Response to referee # 1

Judit Lienert, Jafet Andersson, Daniel Hofmann, Francisco Silva Pinto, Martijn Kuller, "Using Multi-Criteria Decision Analysis for transdisciplinary co-design of the FANFAR flood forecasting and alert system in West Africa". hess-2021-177

This manuscript was written for the HESS Special Issue "Contributions of transdisciplinary approaches to hydrology and water resources management"

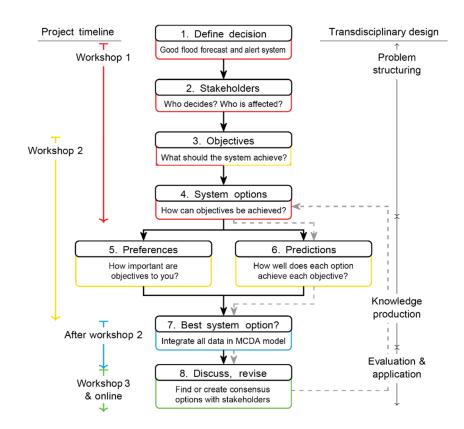
3) There are lots of unjustified claims and procedural statements. There is no clear structure of the overall modelling procedure and methods used. New twists and approaches are introduced here and there along the text. The structure used in the modelling seems to be very different from standard procedures so a description and justification is needed in one place not scattered in the text.

Response 3a): We are sorry that referee #1 regards the **modelling procedure and methods as unclear in structure**. Please see Figure 1 in the paper (also see below), showing the MCDA structure. In our opinion, this is clear (and standard procedure). The sections of the paper (Methods, Results, Discussion, and Supplementary Information) follow this stepwise structure. In Figure 1, additionally to the MCDA steps, we cross-reference to the "transdisciplinary design" approach, in order to bridge between these two strands of literature.
